APPENDIX G: PUBLIC INVOLVEMENT CONTINUED

Proposed Intersection Improvement Project on United States (US) 24 at Wabash Street in Wabash County.

US 24 at Wabash Street Intersection Improvement Project

Des No 2000025

FIRE TRUCK TURNING MOVEMENTS

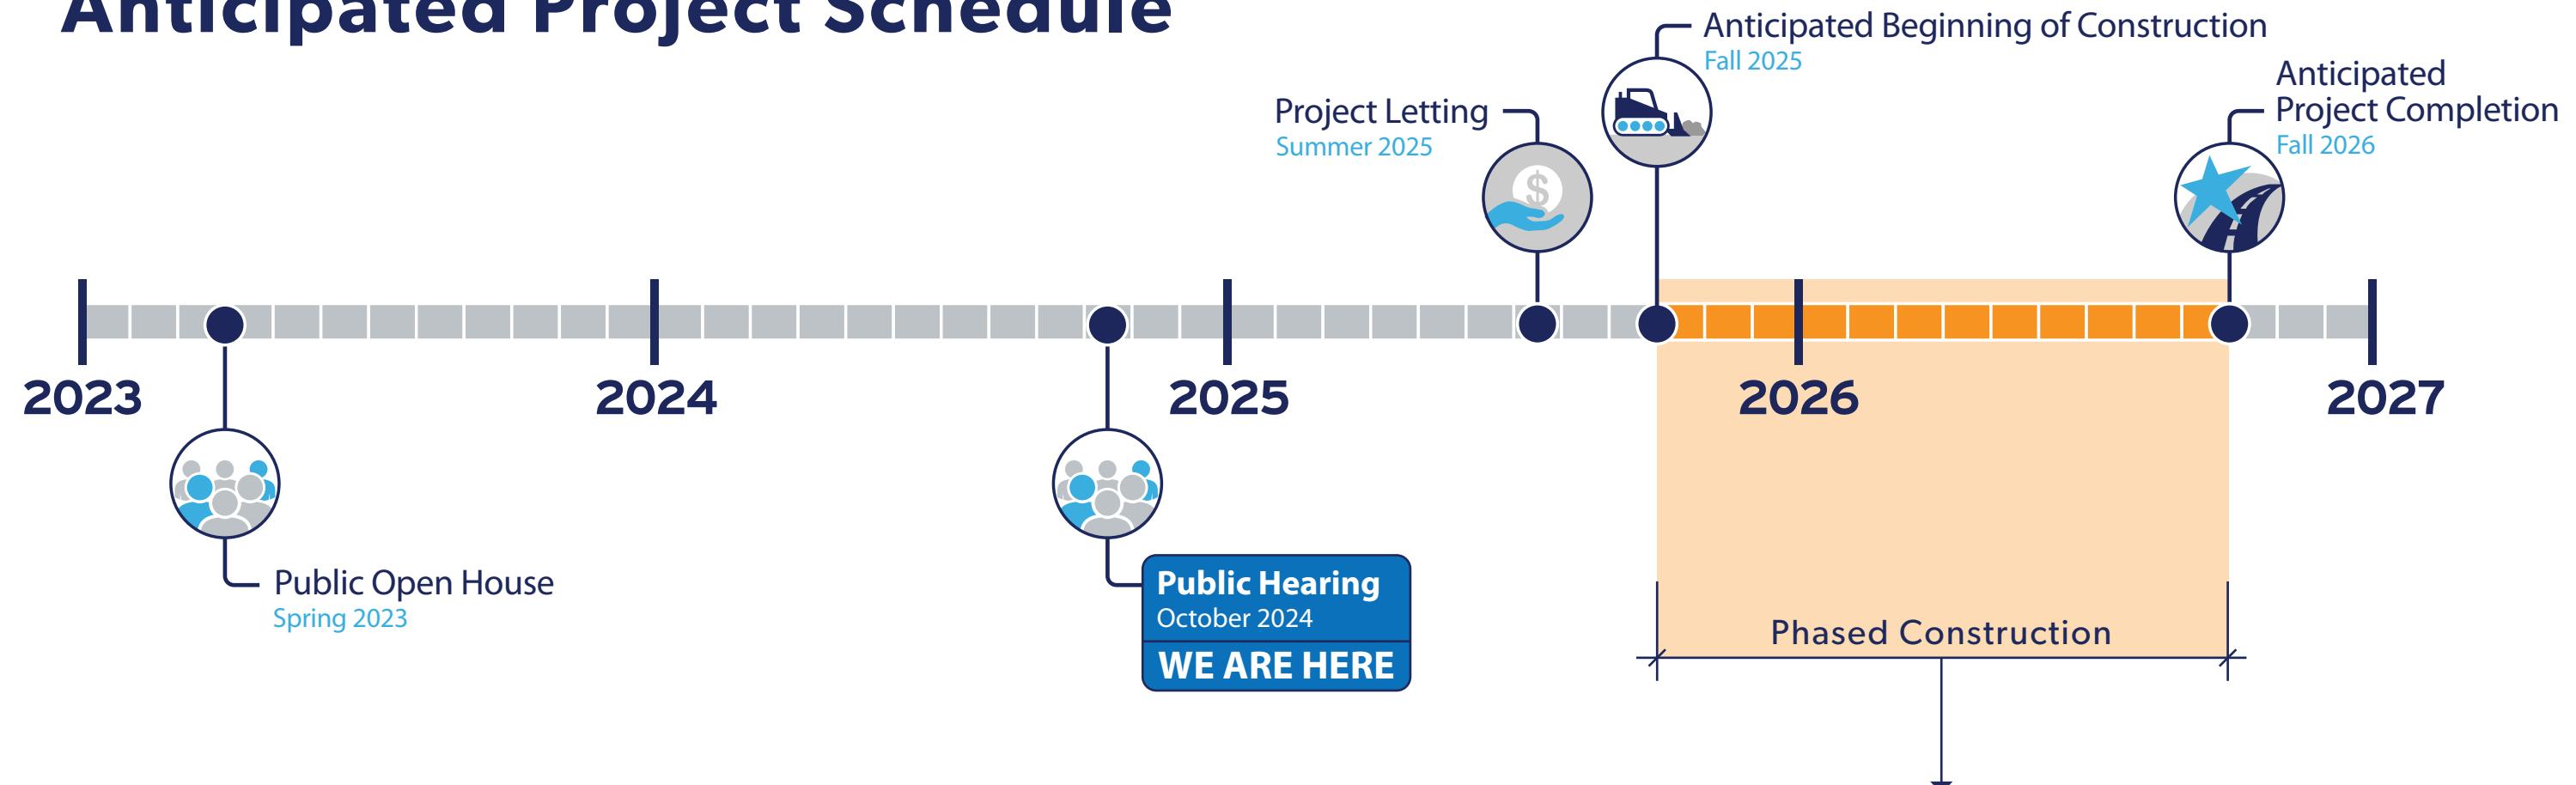
Do you have a drawing of what the final proposed project will look like? Also will this intersection be closed to emergency vehicles during the construction phase of the project?

(**Mayor Scott Long**) Good evening. I'm neutral on this, actually. I just want to say I appreciate INDOT and HNTB listening to our concerns in reference our emergency vehicles, and redesigning what the plan is so that we can safely get large fire trucks to our industrial area, to the northwest, and also allow our ambulances coming from the east side of the county to get to the hospital in an expedient manner.

Generally speaking, the intersection will be open to emergency vehicles during most phases of construction and most traffic movements will be maintained during construction. We will have exhibits that show the phasing of construction and maintenance of traffic at the meeting and would be happy to review those with you.

- The design of this RCI will fully accommodate access of emergency vehicles from Wabash Street onto westbound and eastbound US 24.

TRUCK TURNING MOVEMENTS

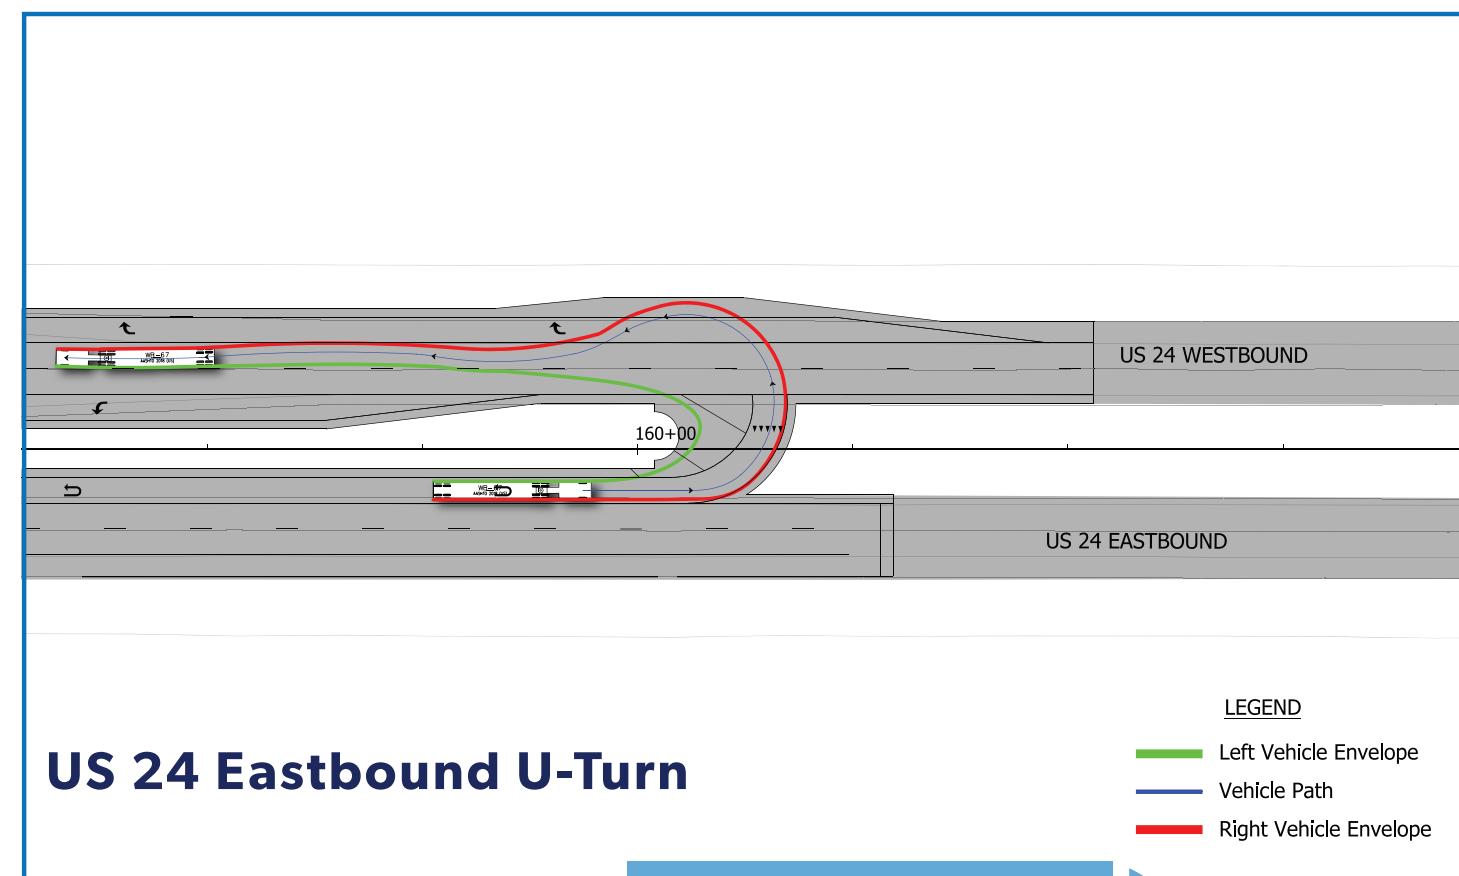
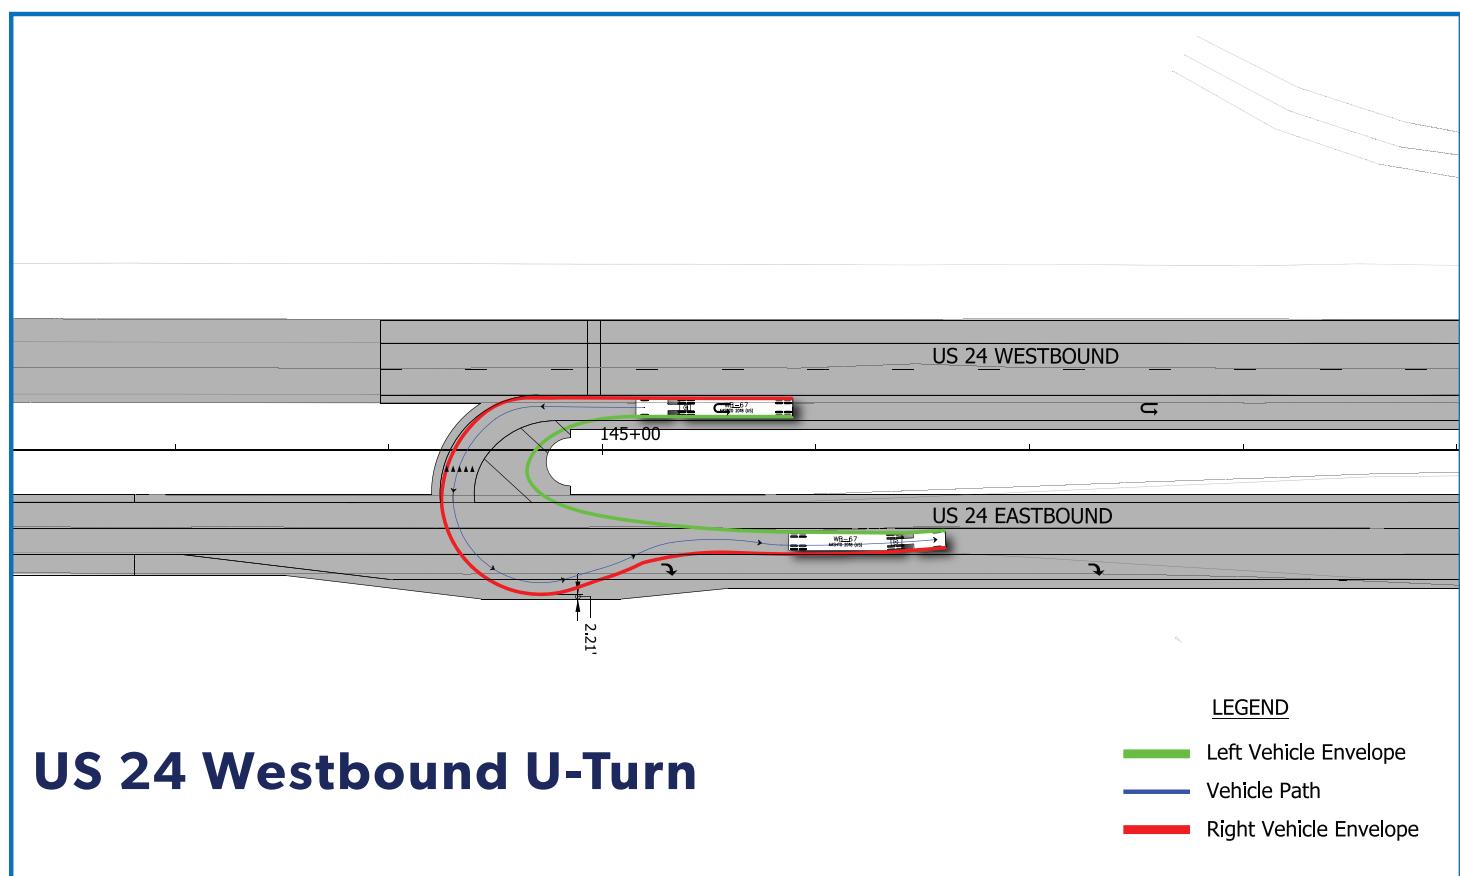
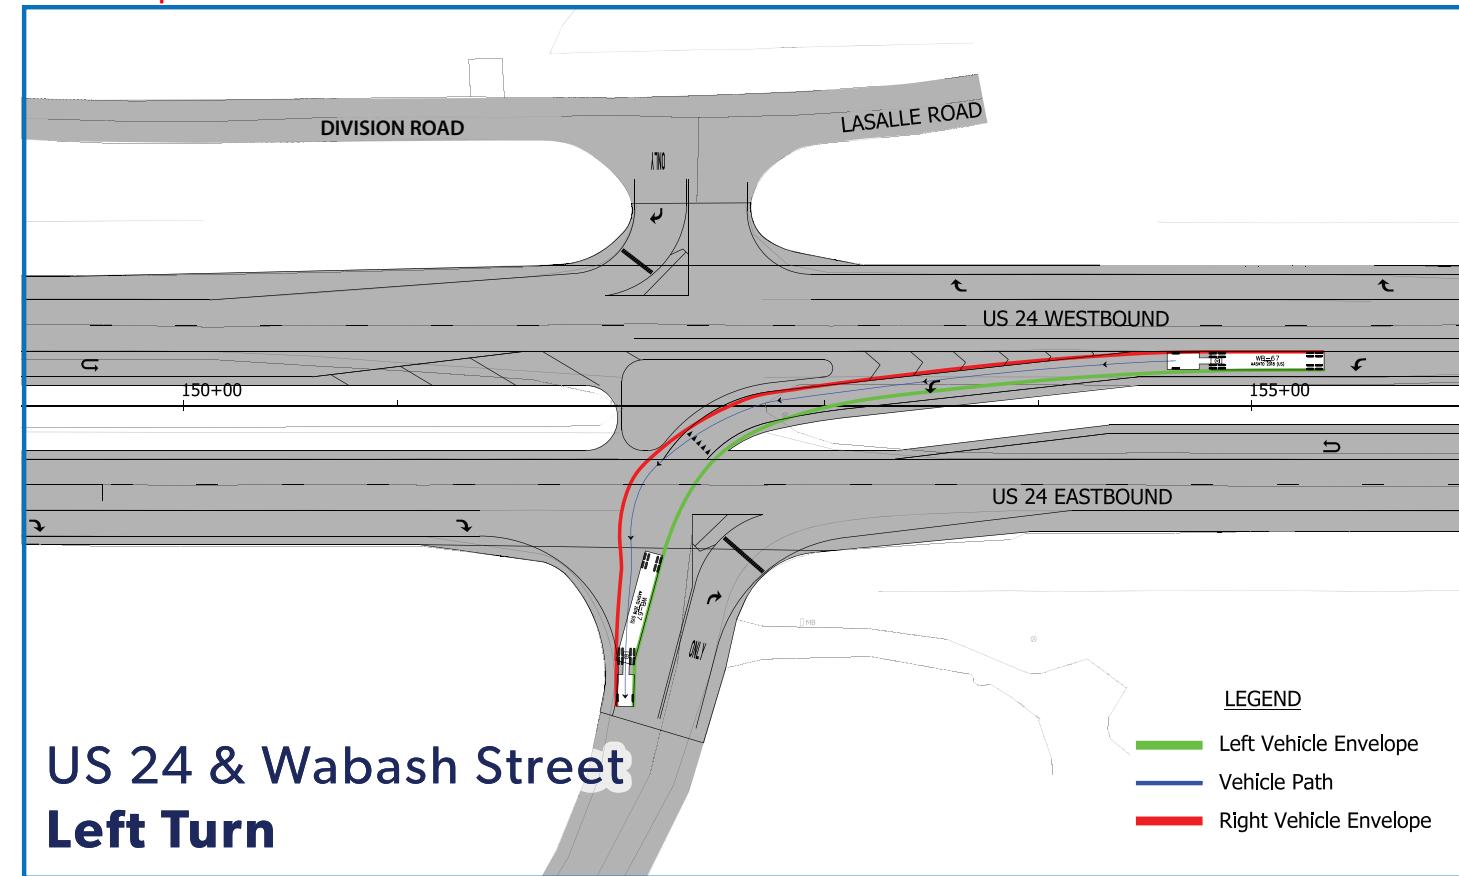
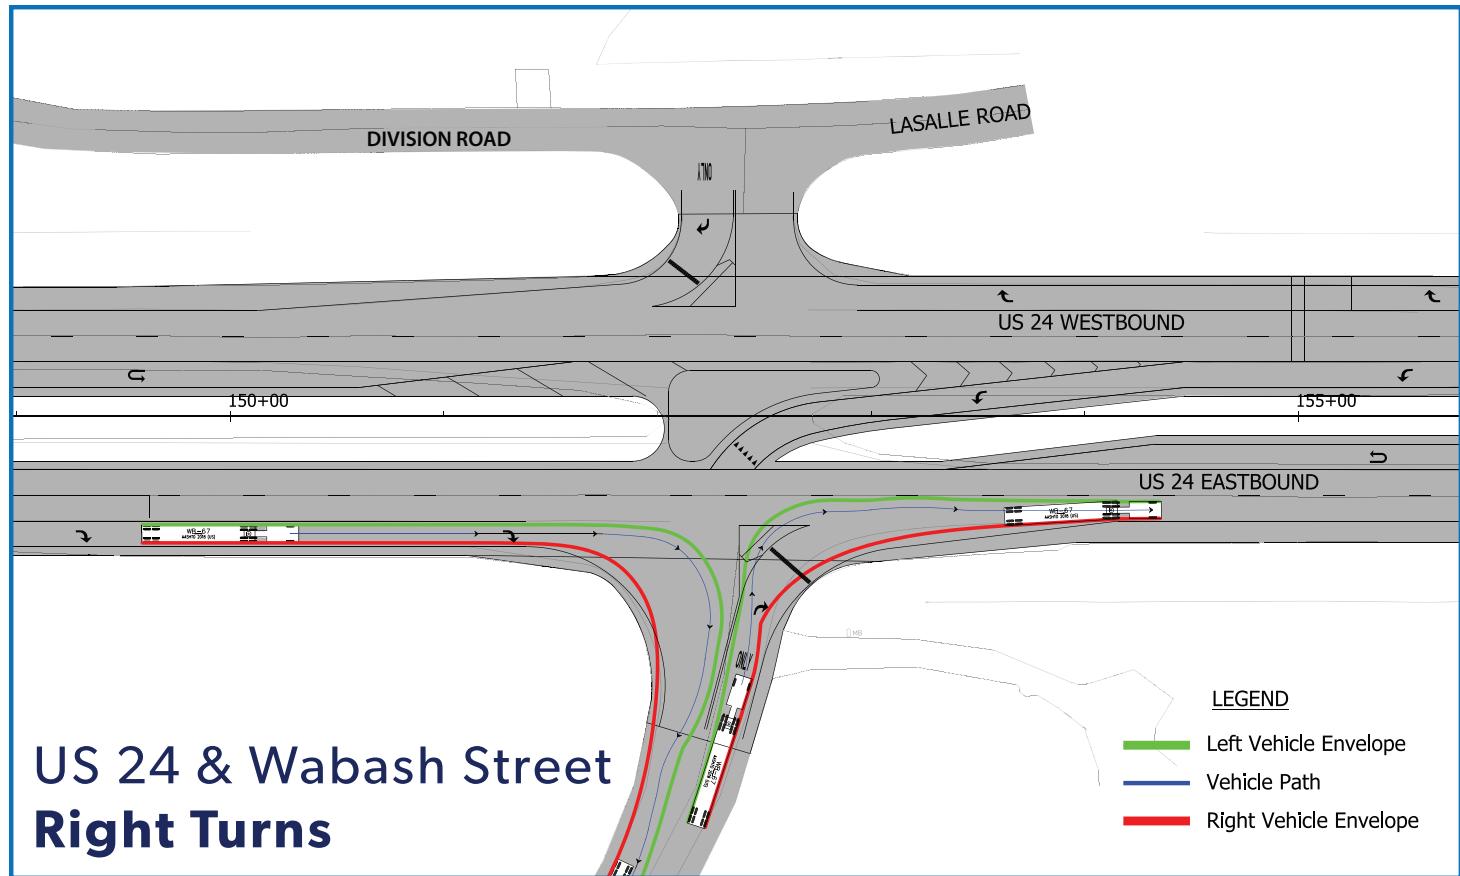
Date	Comment/Question	Category	Resident Name	Organization	Type	Response
10/29/2024	<p>Latheda Metzger with Metzger Farms. So, we're on the corner of Wabash Street and US 24, and I just want my concern documented. We have to swing out of our farm, go right, take the U-turn to LaSalle Road, go around a curve to access the rest of our farm ground. Now, the initial early coordination meeting was dated January 31, 2022. We were not invited, but someone did give us a tip, and we did attend. I believe the church was notified, but we were not. Most of our farm ground is north of US 24. Now, in the video, those were perfect scenarios straight across the road. This is not. You've got Division/ LaSalle Road. We've got students that are off of school. We try to avoid that time, but they're mostly in the middle of that intersection. Doesn't matter. Our concern is the liability with trucks and large farm equipment and the businesses located up [County Road] 150. Now, during the discussion, they couldn't tell me how wide Division/LaSalle Road intersection was to take the equipment and turn it around to head north. I would like to make a suggestion if this happens; that is not wetland. That was cut in 1966, and it was never repaired so that's why there's cattails. The curve on LaSalle Road is a very dangerous curve for the MSD students. They miss it. They wreck it. I don't have the statistics. Mayor Scott Long, where are you? On your phone, okay. Would your police department have those statistics of the accidents? Now, another concern is, yes, the emergency vehicles can drive straight over that curb. Police sit there. We're going to be fined if we can't navigate. The end.</p>	Access, Safety	Latheda Metzger	Metzger Farms	Verbal	<p>Thank you for your comment. It will be included in the official record for this project.</p> <p>A Preliminary Field Check was conducted on January 31, 2022. The meeting included members of the project team, as well as representatives from the municipality. This was not a public meeting. Notification of the public information meeting held on March 28, 2023, at the Honeywell Center was sent to adjacent property owners.</p> <p>Reducing crashes that result in incapacitating injuries and/or fatalities is the goal of this intersection improvement project. The reduced conflict intersection (RCI) design accomplishes that by reducing the number of potential conflict points – or locations where traffic movements cross paths and potential crashes can occur. The current intersection design has 42 potential conflict points. The recommended RCI design reduces the number of conflict points by 40%.</p> <p>Crash data for US 24 and Wabash Street is available in the Categorical Exclusion Level 1 document, Appendix I, pages 6-7. That document is available online at: https://www.in.gov/indot/about-indot/central-office/welcome-to-the-fort-wayne-district/us-24-at-wabash-st.-intersection-improvement-project/.</p> <p>The area of concern at Lasalle and Division has been evaluated and design updated to provide additional pavement to accommodate the required design vehicle.</p>

The proposed RCI design accommodates large vehicles, including semi tractor trailers and farm implements. Graphics that illustrate large vehicle movements are attached immediately following this comment/response spreadsheet.
						The time spent crossing the US 24 and Wabash St. intersection during peak times will likely decrease with the new intersection configuration. Because there is only one direction of traffic to contend with, travel is also made safer and the intersection is easier to navigate, reducing the potential for severe and/or fatal crashes.
						While some minor traffic diversion may occur as a result of this project, it is not expected to significantly impact other adjacent intersections. INDOT monitors intersection safety and congestion and if a need arises at or surrounding this location, additional improvements would be considered & included in the state's Capital Program as deemed appropriate.
